**Comments from India on Informal document Inf. 59-24 dated 3 February, 2006 on
GTR for Motorcycle Braking
(Note : Comments are given in bold, italic, blue letters)**

Brake fluid Reservoir for Split service brake system

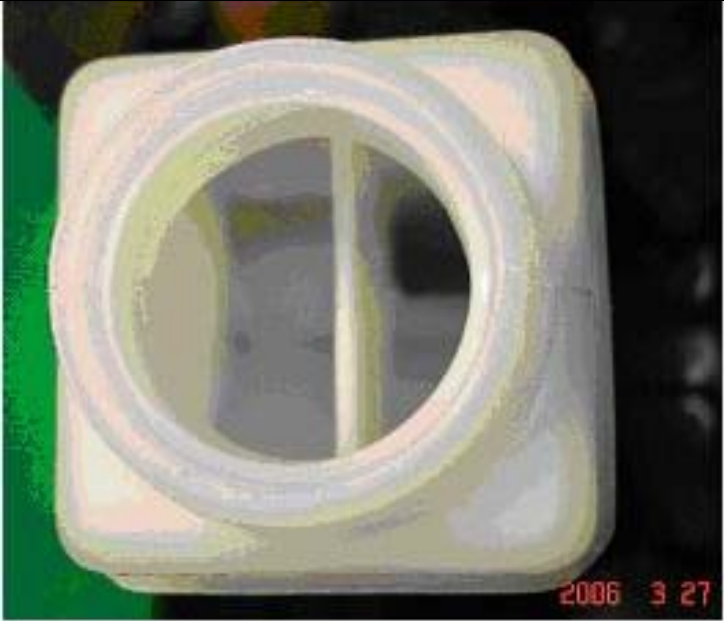
7.	3.1.10. a	have a sealed, covered, separate reservoir for each brake system. <i>A single reservoir with partition for each sub-system with a sealed cover is permissible provided requirements of (b) and (c) below are met for each subsystem.</i>	A common reservoir with a partition separating the container is equally effective. Use of such containers is very common in India both for 3 wheelers and 4 wheelers. Typical pictures of such a reservoir is attached at Annexure - A . The amendment is suggested to permit use of such reservoirs. India had suggested this earlier also and agreed to review the same in the next meeting and amend it accordingly.

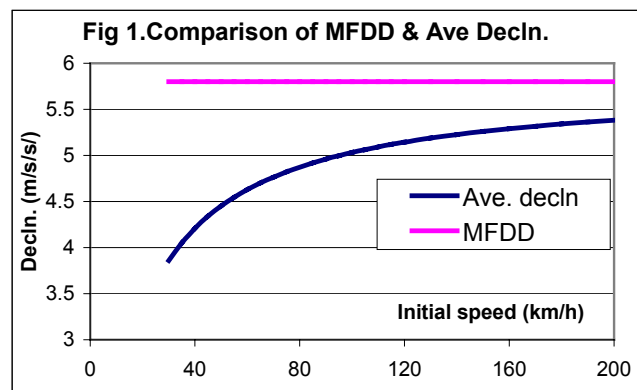
Figure 1 illustrates this. For plotting this graph:

- Stopping distance has been calculated as per ECE formula corresponding to MFDD of 5.8 m/s^2 for various test speeds.
- Average deceleration is calculated from the stopping distance.

This graph also shows that for same MFDD, the average deceleration increases with the test speed.

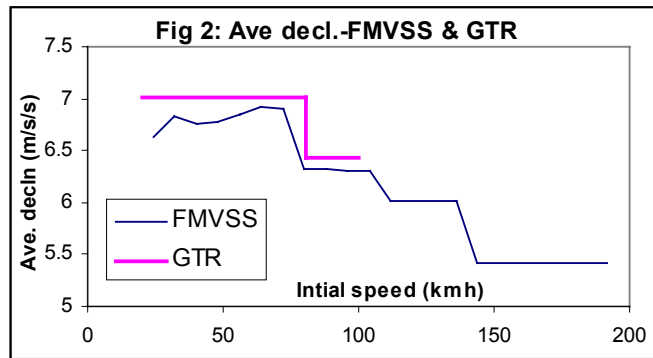
1.5 Figure 2 shows the average deceleration calculated from the stopping distances prescribed in FMVSS.

- 1.6 The expected average deceleration in both cases reduces with the increase in test speed, which is against the basic principles of braking. In practice these limits mean that the brake design has to be superior in the case of vehicles tested at higher speeds as it has to provide a higher braking torque to achieve the higher average deceleration. It can also be seen that the GTR requirements are more stringent than FMVSS. Also the increase in stringency is more at lower test speeds.

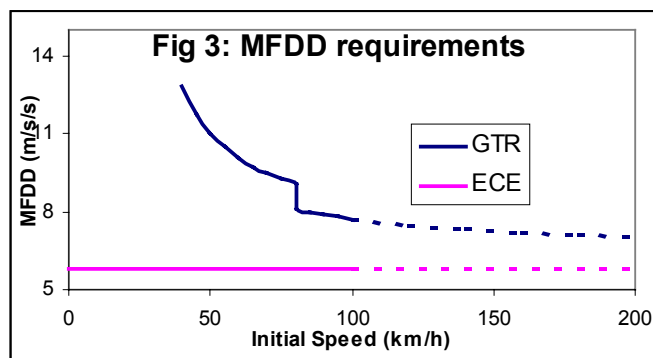
- 1.7 The increase in the stringency is highlighted if the MFDD for which the brake system has to be designed. The required MFDD has been calculated from the stopping distance using the ECE formula and is shown in Figure 3.
